# Product Safety Recall

## N212335590 Fuel Line May Not Be Properly Secured

**Revision:** 01

5845363

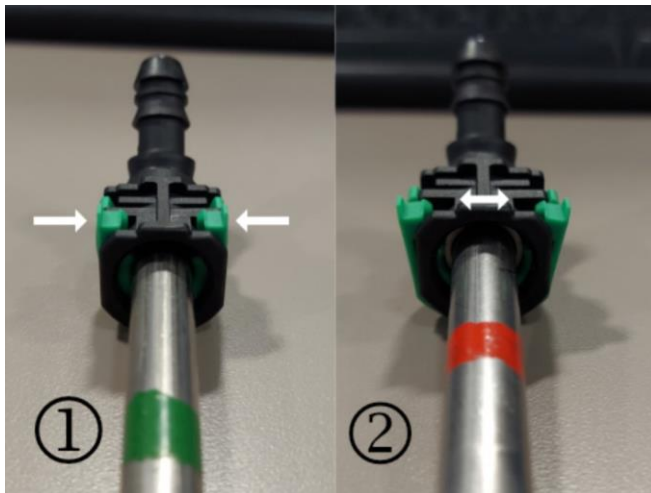
2. Locate the fuel line clip, circled above.

3. Inspect the fuel line clip to be sure the clip is fully seated.
- If the clip is fully seated and the fuel pipe is secure, as shown in (1); no further action is required.
  - If the clip is NOT fully seated, as shown in (2), replace the fuel feed pipe. Refer to *Fuel Feed Pipe Replacement (AWD)* or *Fuel Feed Pipe Replacement (FWD)* in SI.
  - If you are not sure if the fuel feed pipe is fully seated, gently tug on the fuel feed pipe to determine if it is fully seated. If the feed pipe is not securely snapped in, or if you are in doubt that it is secure, it must be replaced. Refer to *Fuel Feed Pipe Replacement (AWD)* or *Fuel Feed Pipe Replacement (FWD)* in SI.
4. Lower the vehicle. Refer to *Lifting and Jacking the Vehicle* in SI.
